Work Order ID 155016

Item Name: AW119 Replacement Skidtube with Standard Wearplates & Wearpads, Fits LH & RH

DRAWING NO. D3887	TITLE A119 STD SKIDTUBE ASSY	REV. D	DART AEROSPACE USA, INC. ENGINEERING ORDER		D.E.O. NO. D3887-D-1	SHEET NO. SHEET 1 OF 3	SCALE NTS
DRAWN AJS		CHECKED		MFG. APPR.	APPROVED	DE APPR.	
DATE 16.11.08		DATE		DATE	DATE	DATE

DRAWING NO. D3887	TITLE A119 STD SKIDTUBE ASSY	REV. D	DART AEROSPACE USA, INC.	D.E.O. NO. D3887-D-1	SHEET NO. SHEET 2 OF 3	SCALE NTS
DRAWN AJS	CHECKED	MFG. APPR.	APPROVED	DE APPR.		
DATE 16.11.08	DATE	DATE	DATE	DATE

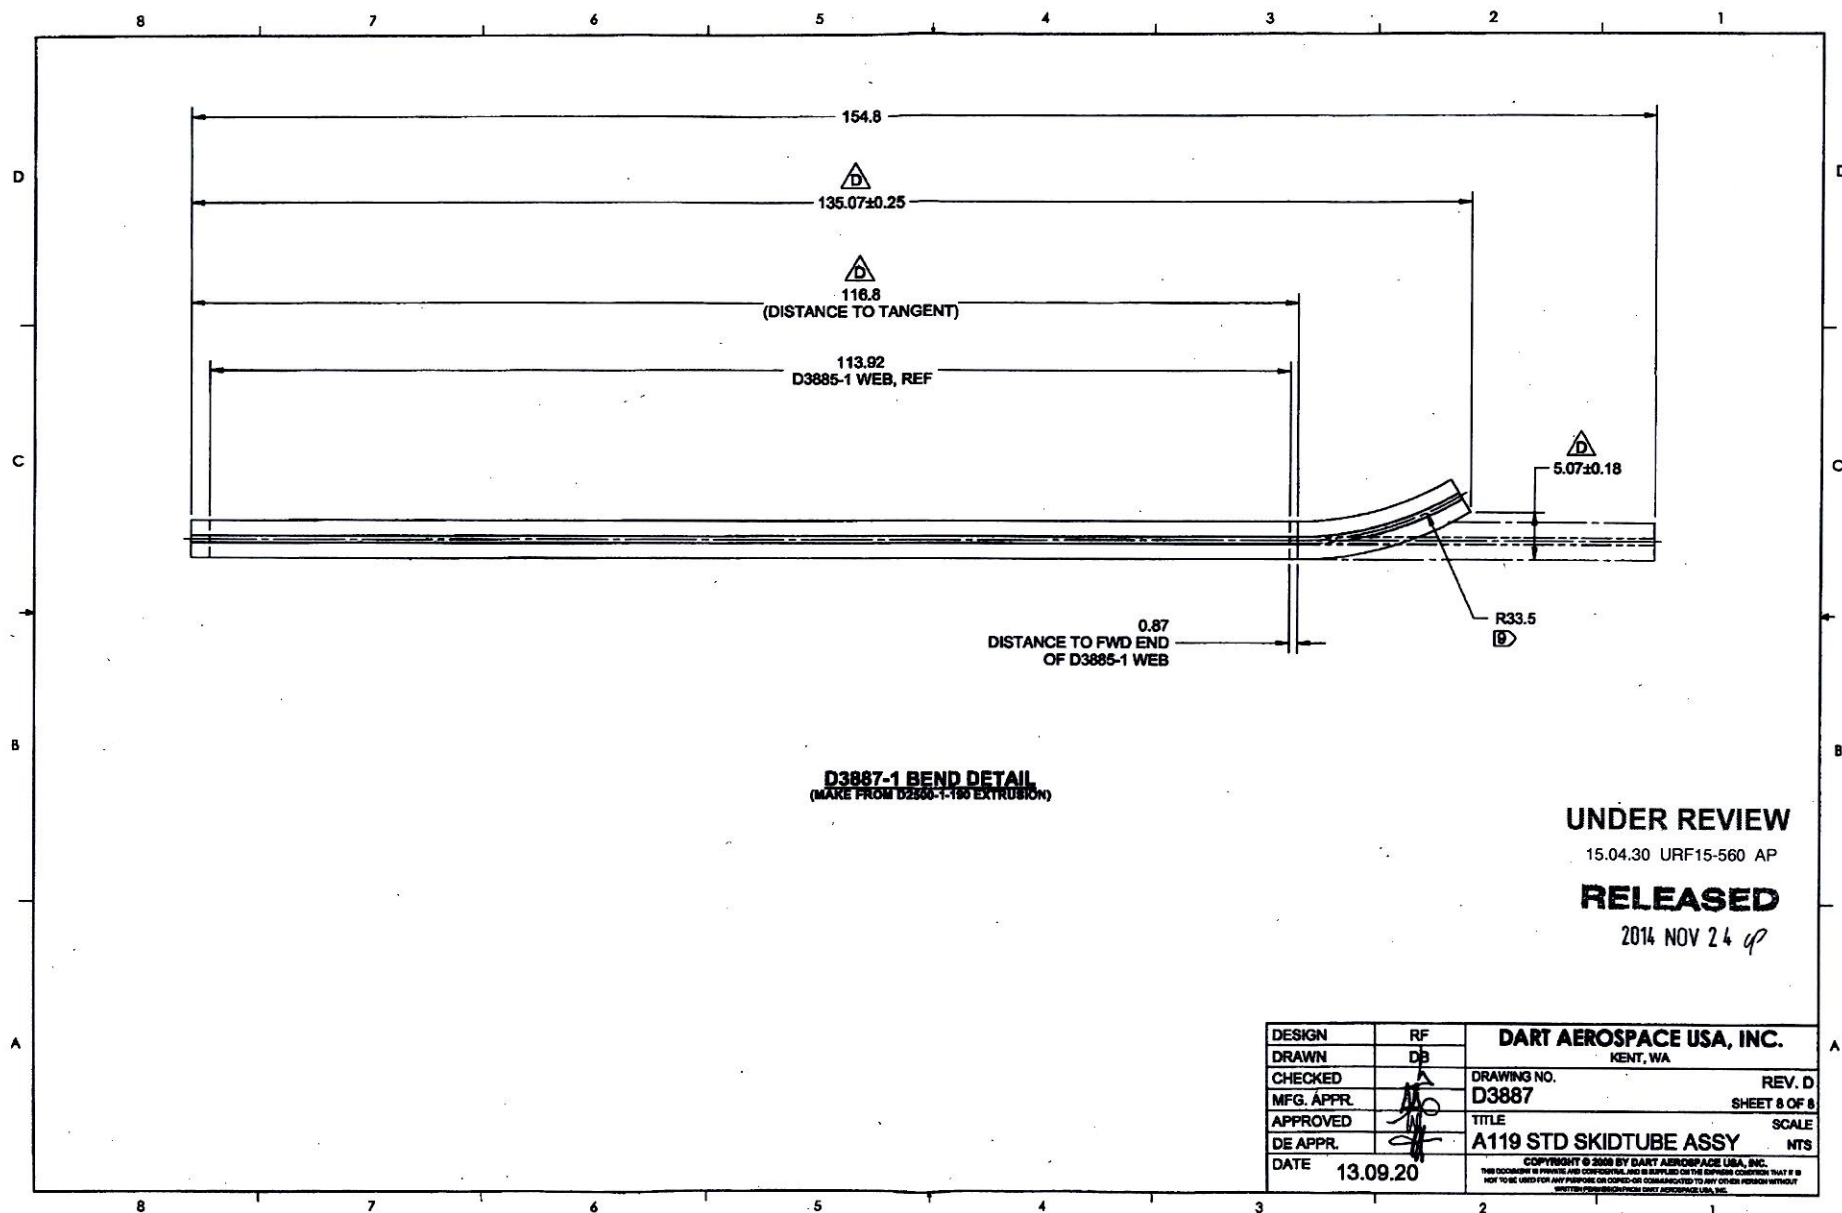
SHEET 1 MODIFY PARTS LIST AS SHOWN:

(ADD)	47	6		AN3C4A	BOLT
-------	----	---	--	--------	------

SHEET 1 ADD NOTE 13 AS SHOWN:

13) MASK THIS AREA. DO NOT APPLY PRIMER OR PAINT

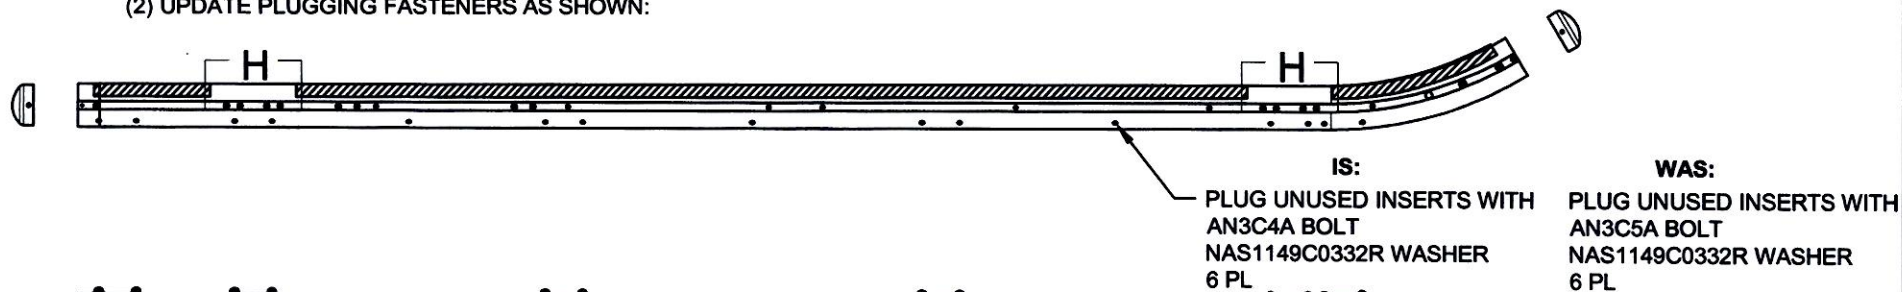
SHEET 2: (1) ADD DETAIL H
(2) UPDATE PLUGGING FASTENERS AS SHOWN:

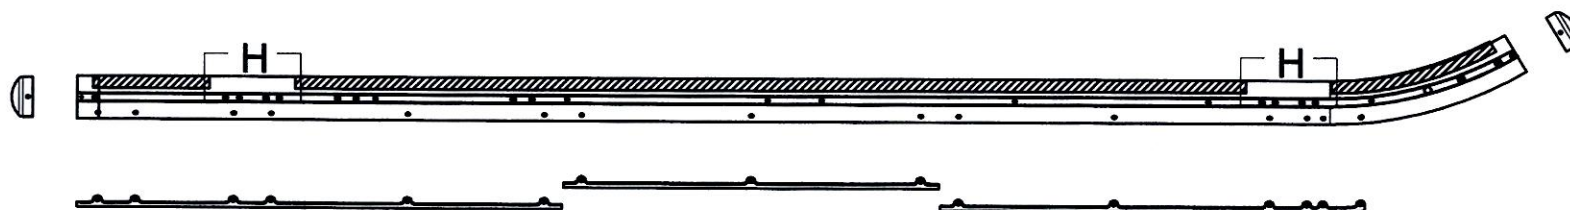
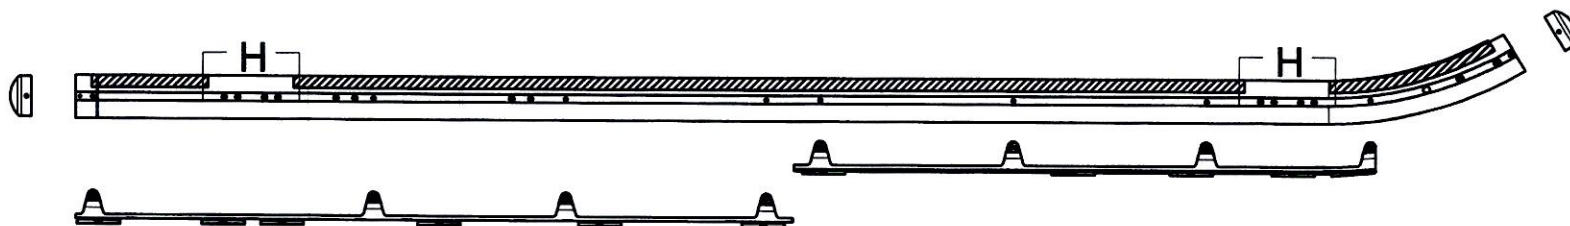
SHEETS 3 AND 4 ADD DETAIL H

DETAIL H

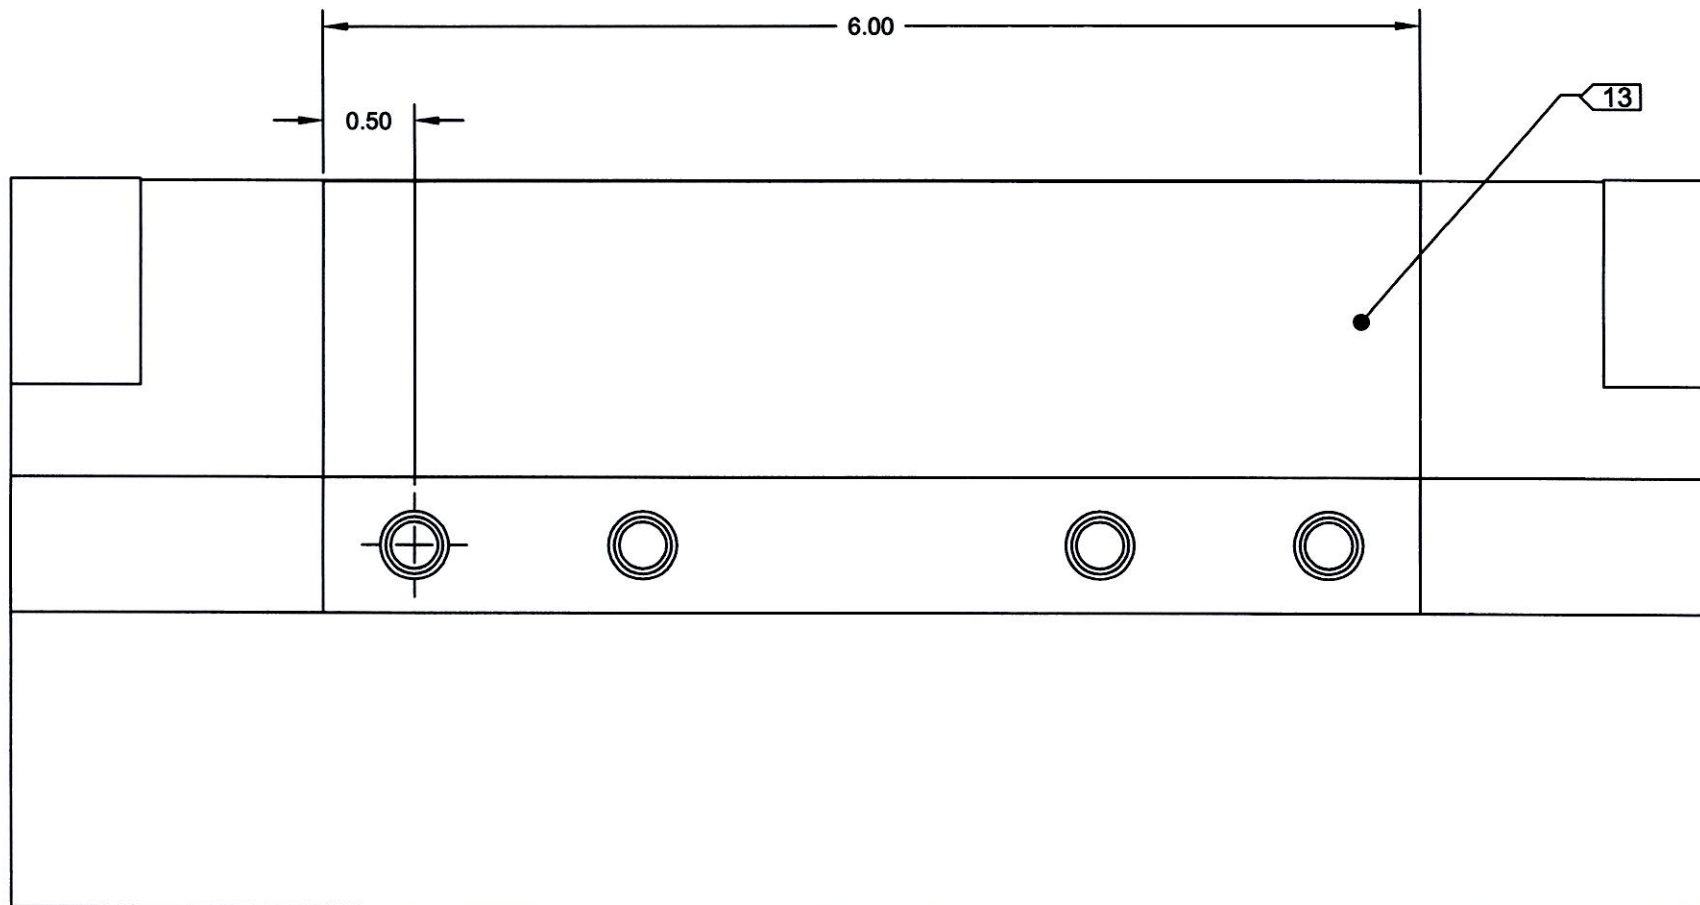
SHEET 7 ADD DETAIL H TO THE FACE OF DRAWING AS SHOWN:
